APPROVED
ALVORD, BURDICK & HOWSON
BY *[Signature]*
DATE 5/26/52
For general design only
with corrections as shown

MONTAGUE-BETTS COMPANY LYNCHBURG, VIRGINIA			
REINFORCING STEEL GARDEN CITY RESERVOIR ROANOKE, VIRGINIA			
ARCHITECT: ALVORD, BURDICK & HOWSON			
CONTRACTOR: J. E. JEWELL			
REVISED	DRAWING NO.	ORDER NUMBER	SHEET NO.
DWG. R.M.	15138	15138	1 of 3
CHKD. S.M.			
DATE

FLOOR SLAB

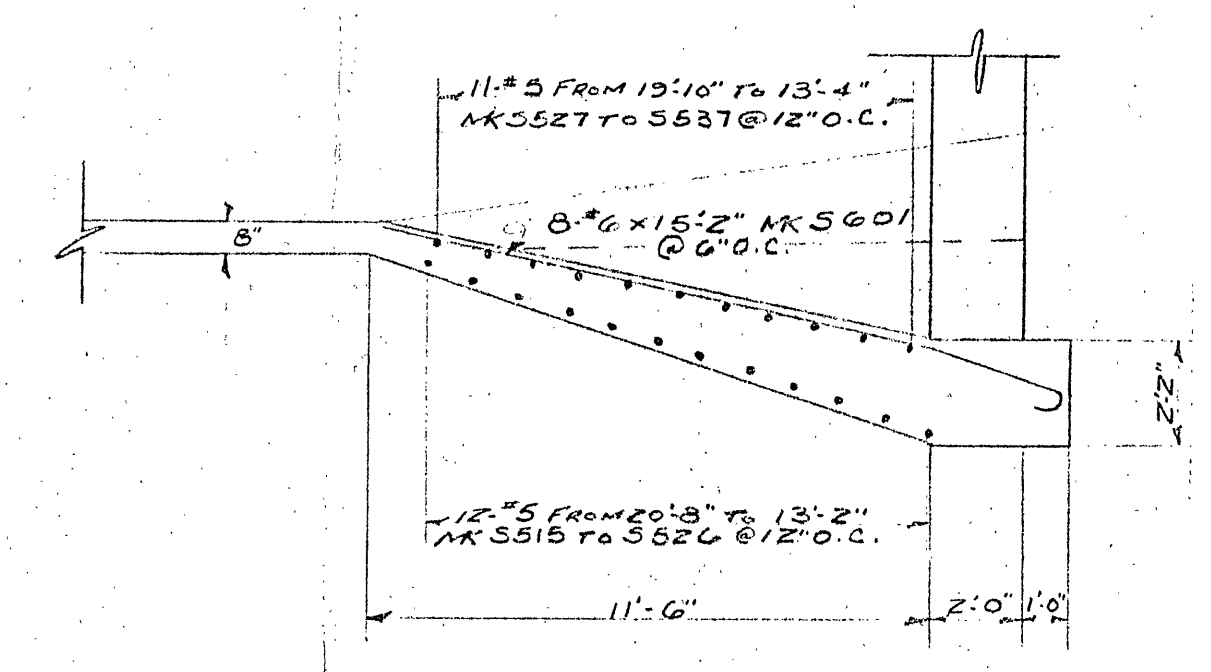
Note: All column footings should have a total of 20 bars in each direction in bottom of slab. 8 bars bent down from each end + 4 straight bars 12'-0" long (same as roof but inverted)
